ACCESSION NBR: 8607150183 DOC. DATE: 86/07/10 NOTARIZED: NO DOCKET #
 FACIL: 50-315 Donald C. Cook Nuclear Power Plant, Unit 1, Indiana & 05000315
 50-316 Donald C. Cook Nuclear Power Plant, Unit 2, Indiana & 05000316
 AUTH. NAME AUTHOR AFFILIATION
 ALEXICH, M. P. Indiana & Michigan Electric Co.
 RECIP. NAME RECIPIENT AFFILIATION
 DENTON, H. R. Office of Nuclear Reactor Regulation, Director (post 851125)

SUBJECT: Application for amends to License DPR-58 & DPR-74, changing
 Tech Spec 3/4.7.5.1 re control room emergency ventilation
 sys & adding Tech Spec 3/4.3.3.11 re chlorine detection sys,
 per NUREG-0737, Item III. D. 3. 4. Fee paid.

Donald C. Cook Nuclear Plant Unit Nos. 1 and 2
Docket Nos. 50-315 and 50-316
License Nos. DPR-58 and DPR-74
CONTROL ROOM VENTILATION AND CHLORINE DETECTION
TECHNICAL SPECIFICATIONS

ATTACHMENT 1 TO AEP:NRC:0856 0
REASONS AND 10 CFR 50.92 ANALYSES FOR
CHANGES TO THE DONALD C. COOK NUCLEAR PLANT
UNIT NOS. 1 AND 2
TECHNICAL SPECIFICATIONS.

FIGURE 1: CONTROL ROOM VENTILATION SYSTEM

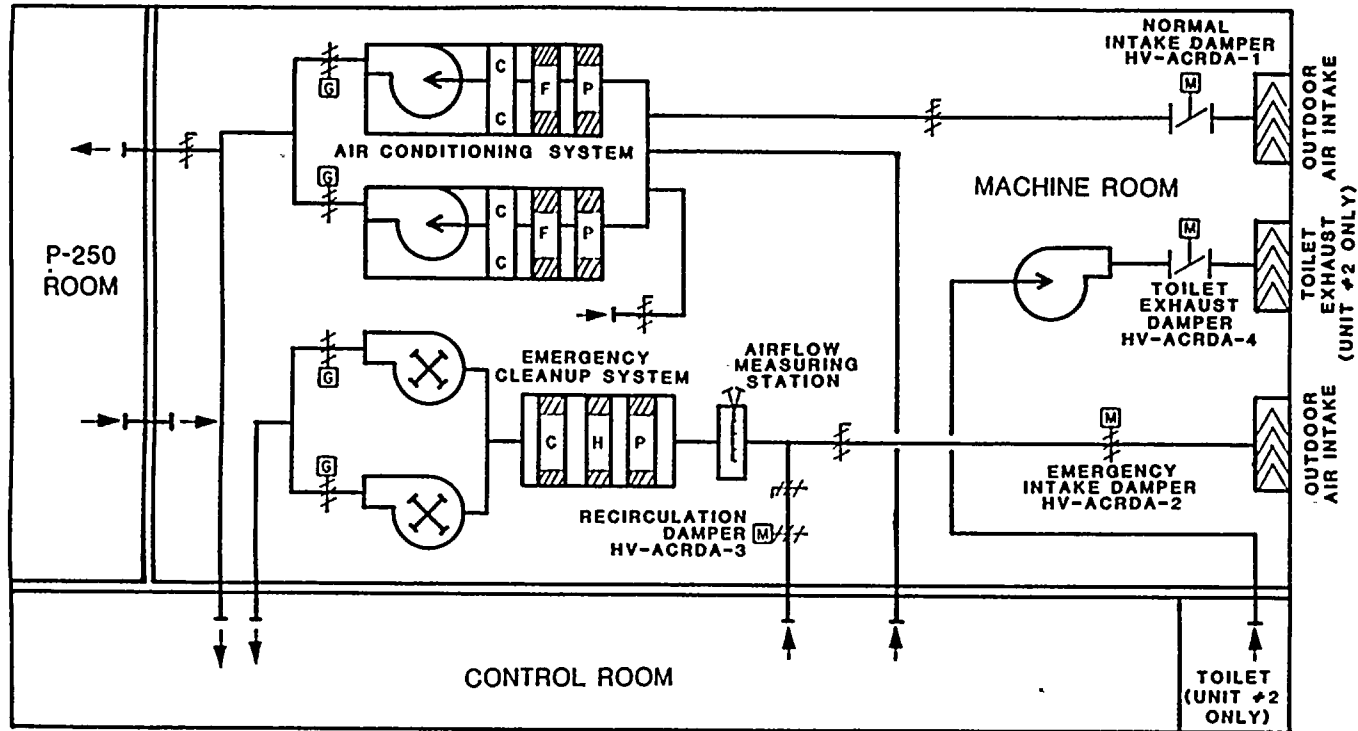
Figure 1 is a simplified flow diagram of the control room ventilation system. It also shows the layout of the various rooms which are served by the control room ventilation system. These rooms include the control room itself, the HVAC machine room (which houses the various ventilation equipment), and the P-250 computer room.

We also propose to add a surveillance requirement (4.7.5.1.e.4) for the pressure in the HVAC machine room and P250 computer room. We have included a sketch as Figure 1 which illustrates the layout of the areas and their communication paths. Under radiological accident conditions, the control room itself would be maintained at a positive pressure of at least 1/16 inch W.G. relative to the outside atmosphere by operation of one of the redundant pressurization fans. The HVAC machine room and the P250 room would not be expected to be entered or exited very frequently in the event of an accident, as would be expected for the control room itself. Therefore, their design provides pressures above ambient, but potentially lower than the control rooms. Thus, our proposed T/S 4.7.5.1.e.4 requires a surveillance on an 18-month basis to verify that pressures are positive with respect to the outside atmosphere. We note that air is supplied directly to the P-250 computer room, and then transfers to the machine room via transfer grills located in the wall between the rooms. Pressure in the P-250 computer room would always be

slightly higher than the machine room because of the small pressure drop associated with air passage through the transfer openings. Therefore, positive measurement in the machine room will ensure a positive pressure in the computer room.
